On 21 December 2022 we received from ICOMOS the "World Heritage List 2023 - Koninklijk Eise Eisinga Planetarium (Royal Eise Eisinga Planetarium) (Netherlands) – Interim report and additional information request". (Ref. GB/EG/1683/IR)

## Property Eisinga Planetarium in Franeker

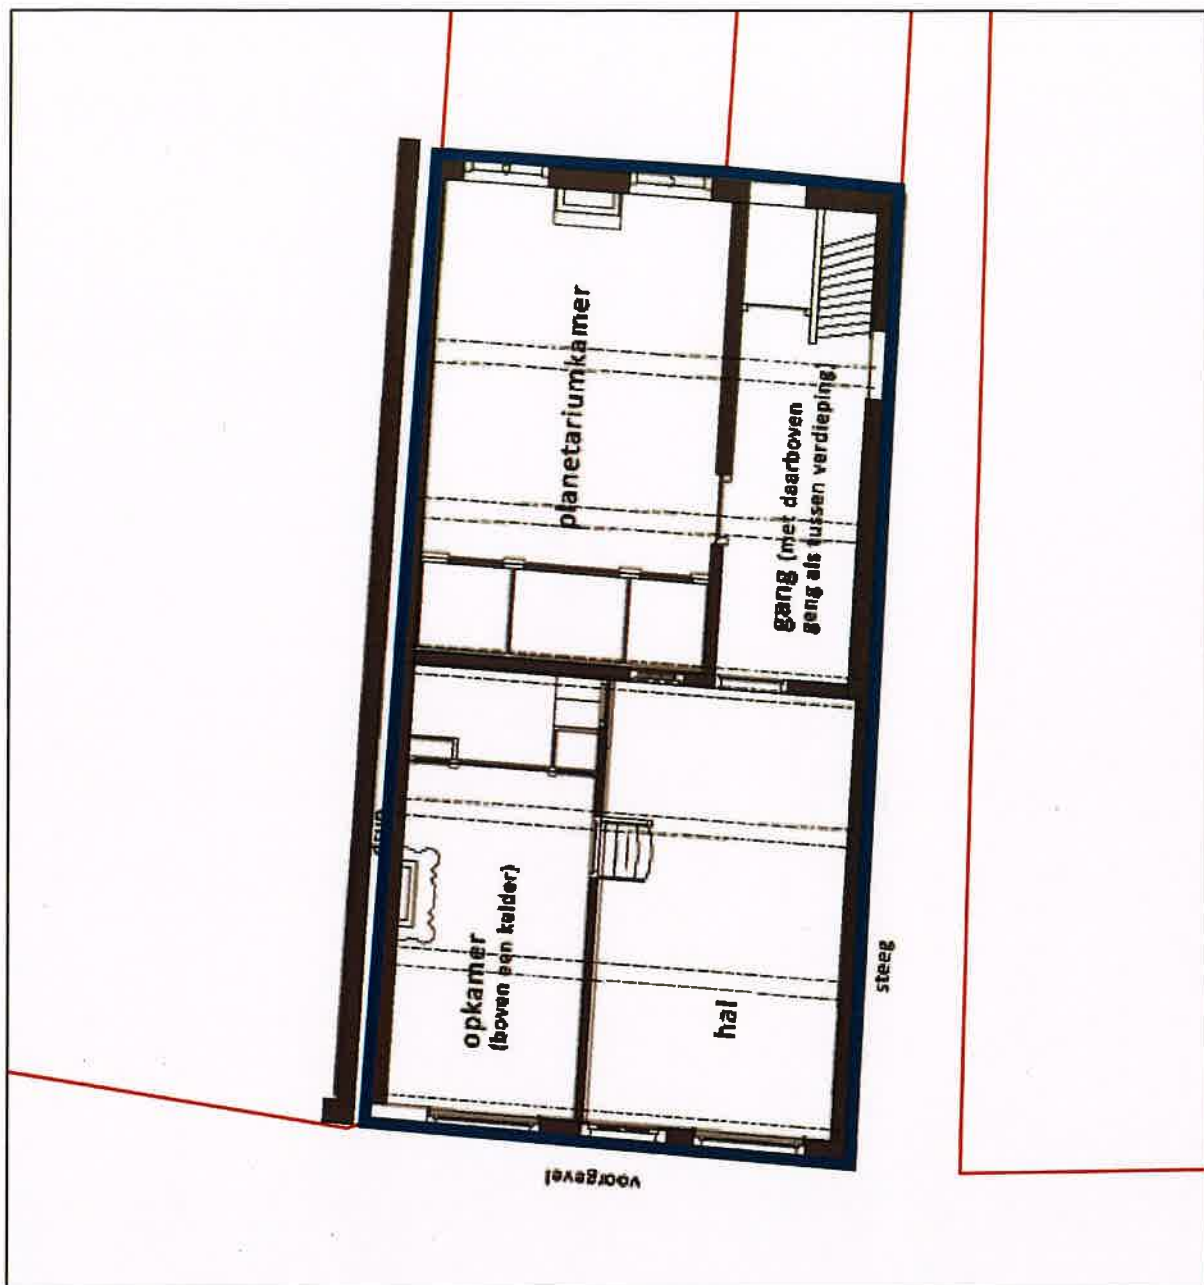
“.. For these reasons, ICOMOS considers that the boundaries of the nominated property should be drawn to include the totality of the building that existed at the time the planetarium was constructed, in order to meet the conditions of integrity. Hence, ICOMOS would appreciate if the State Party could consider reviewing the boundary of the nominated property accordingly and submit the respective new maps.”

It will be no problem for the State Party to adjust the boundary of the property as requested by ICOMOS. The boundary of the property was the subject of extensive discussions when preparing the nomination file. The boundary now proposed by ICOMOS was also considered at the time, but in the end a smaller property was opted for. We are in agreement with the substantive considerations put forward by ICOMOS for expanding the property to include the entire original 15th century house. Furthermore, the existing protection of the – previously submitted - property, its management, etc., also applies to the entire house in which the planetarium is located. Consequently, the expansion of the property can be effected without any problems, and protection and measures will apply to the new property similarly to those applicable to the property as originally submitted.

Below you will find the amended description and the maps showing the new boundary of the property.

Below you will find the cadastral map, indicating the property, and a map of the ground floor of the building. The third map shows the new – expanded – property within the unchanged buffer zone.
